**Town of Nags Head Planning Board
Nags Head Municipal Complex Board Room
Tuesday, June 18, 2024; 9:00 a.m.**

Subject: Site Plan Amendment for Inn at Whalebone, 87-unit Hotel located at 6632 W. Pheasant Avenue (W. Lakeside Street).

At this time, the applicant is requesting that consideration be given to various Site Plan amendments as well as a request to eliminate in whole, or modify, the requirements imposed by Condition #1 as it relates to the widening of Lakeside Street.

PROJECT NUMBER	DRAWING NUMBER
C06001.00	C-102

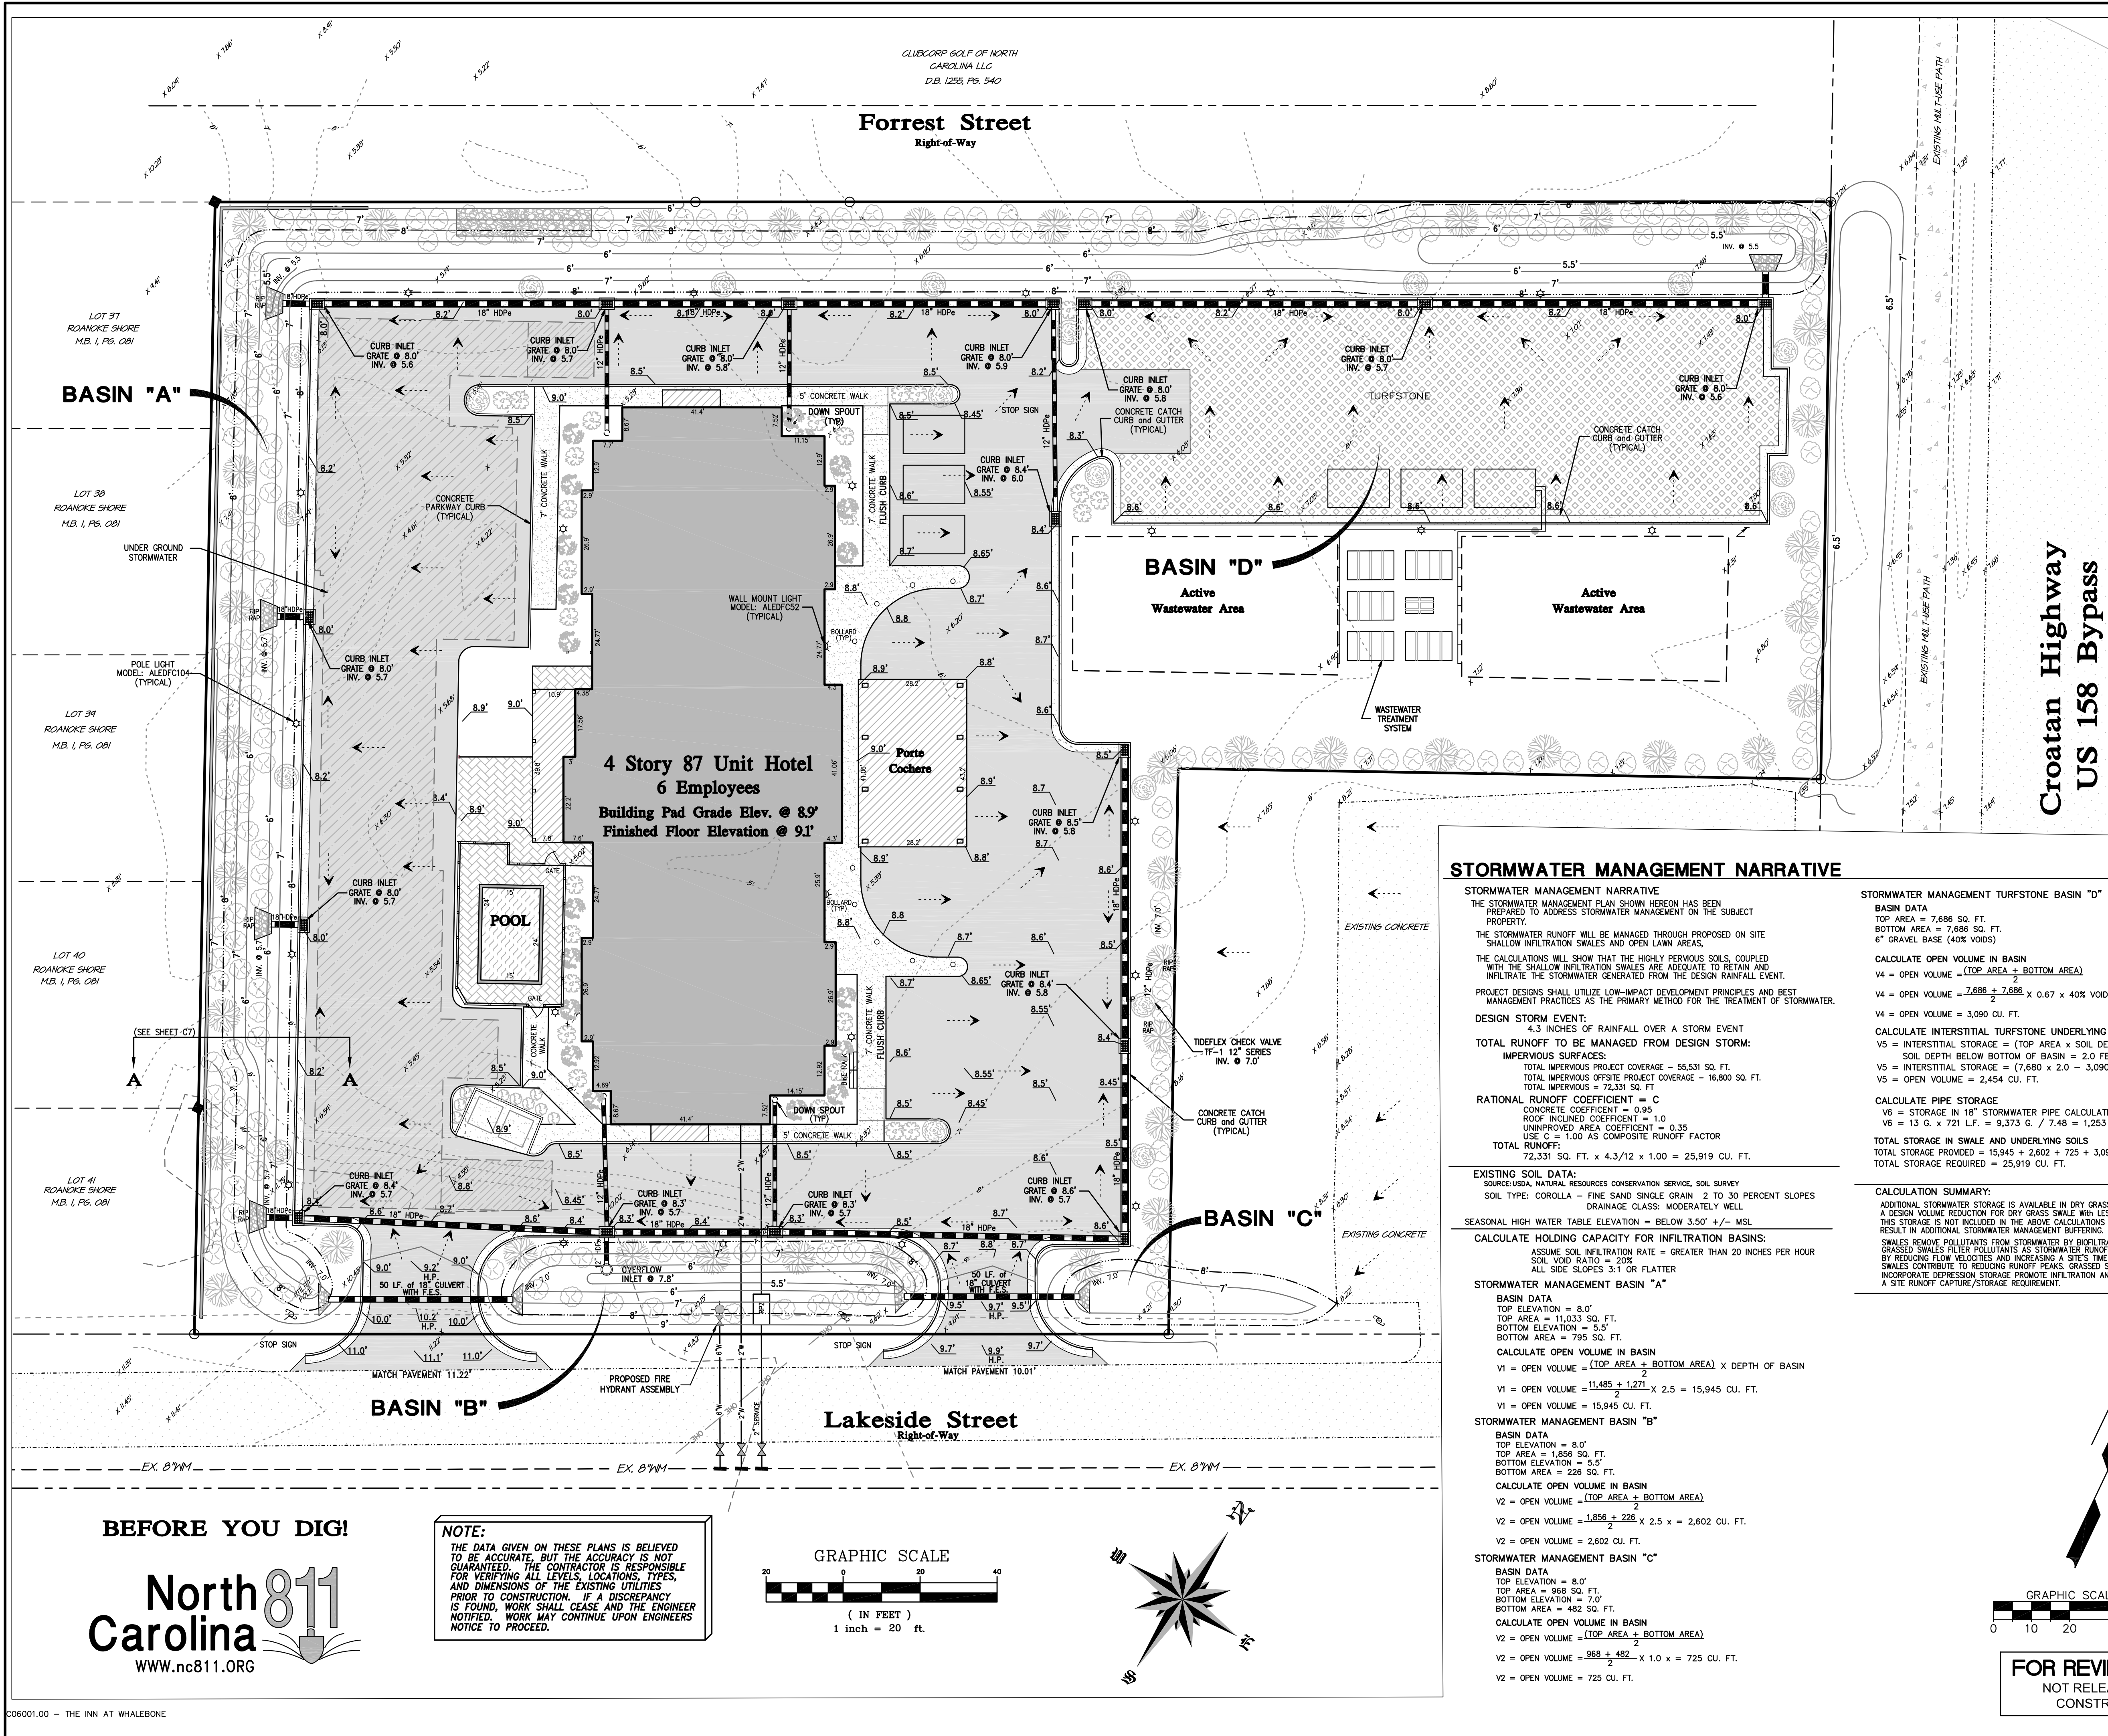
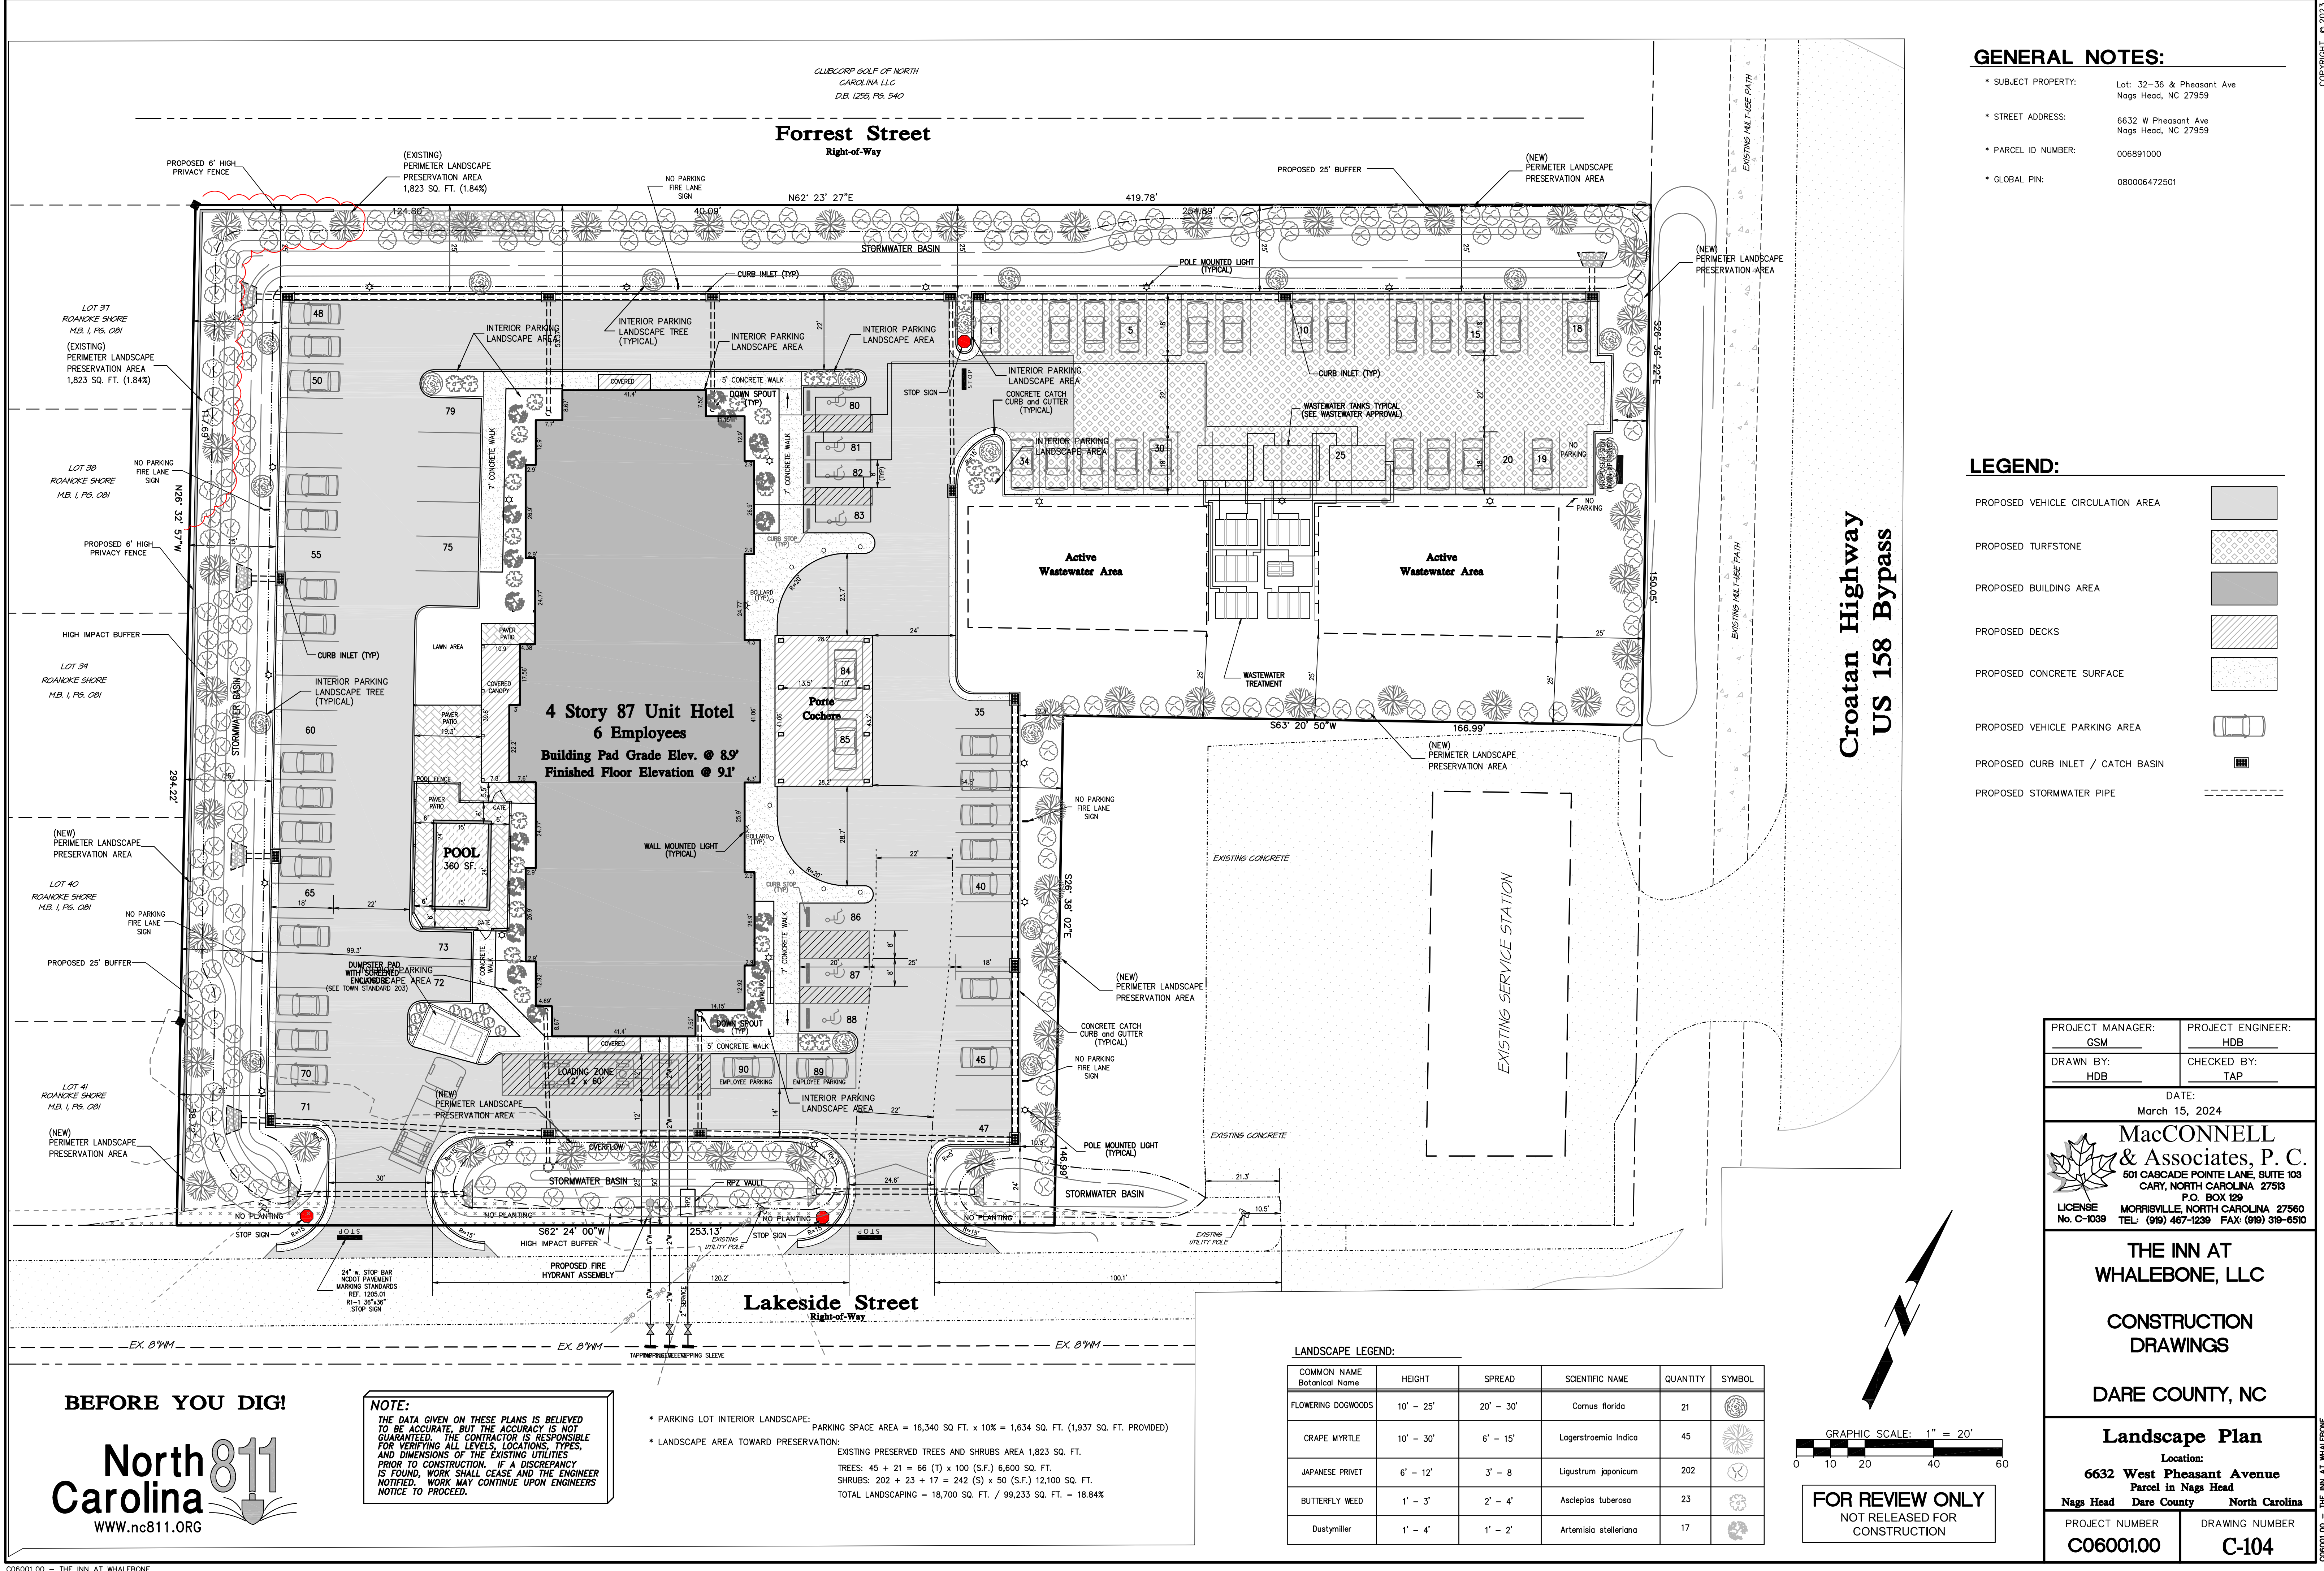
Town Engineer David Ryan has reviewed the revised plans and notes that the stormwater narrative on Sheet C-103 indicates a Seasonal High Water Table Elevation of 3.50' MSL. The typical infiltration basin detail indicates a SHWL of 4.8'. This discrepancy should be clarified. The stormwater management design information submitted appears to be in substantial compliance with the Town of Nags Head Unified Development Ordinance.
